Access Compliance Report

Public Rights-of-Way

Intersection ID: 12268	Main Street: BELLE_TERRE_AV	Cross Street: THE_PLAZA	Location: SE
ADA ID: 940F22C63476	Ramp Type: Directional1	Initial Pass/Fail: Fail	Overall Compliance: No
		Severity Score: 12.5

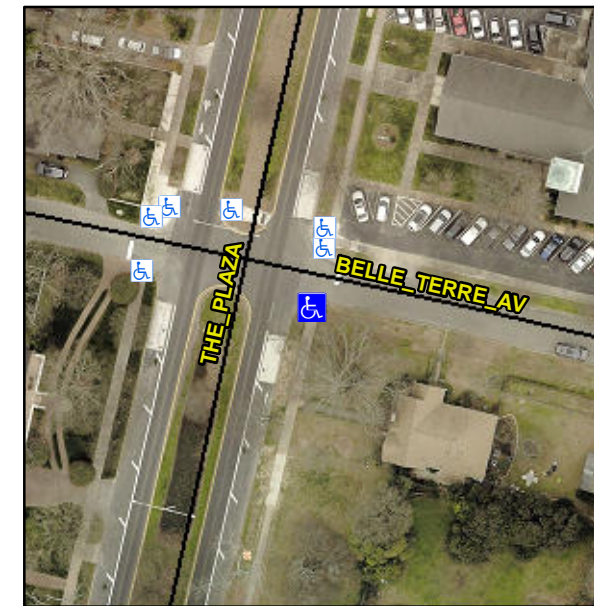
R304.2.2

Compliance	Description	Data	Compliance	Description	Data
N/A	Ramp Length (in)	36.0	N/A	Grade Break?	N/A
Yes	Ramp Width (in)	60.0	N/A	Grade Break Slope (%)	0.0
No	Ramp Slope (%)	11.2	N/A	Grade Break XSlope (%)	0.0
Yes	Ramp XSlope (%)	1.4			
N/A	Flare Type LT	N/A	N/A	Flare Type RT	N/A
N/A	Flare Slope LT (%)	N/A	N/A	Flare Slope RT (%)	0.0
N/A	Flare Traversable LT?	N/A	N/A	Flare Traversable RT?	N/A
N/A	Landing Length (in)	0.0	N/A	DWS Provided?	N/A
N/A	Landing Width (in)	0.0	N/A	DWS Contrast?	N/A
N/A	Landing Slope (%)	0.0	N/A	DWS Length (in)	N/A
N/A	Landing X Slope (%)	0.0	N/A	DWS Full Width?	N/A
N/A	Landing Curb? (Y/N)	N/A	N/A	DWS Offset LT (in)	N/A
N/A	Shared Landing?	N/A	N/A	DWS Offset RT (in)	N/A
N/A	Gutter Ponding?	Yes	N/A	Gutter Slope (%)	N/A
N/A	Gutter Lip Ht (in)	0.0	N/A	Gutter X Slope (%)	N/A
N/A	Painted X Walk1?	No		Road Slope (%)	4.3
	X Walk 1 Direction	To N		Road X Slope (%)	0.1
	X Walk 1 Width (in)	N/A		Clear Space?	N/A

Remove & Replace Entire Ramp.
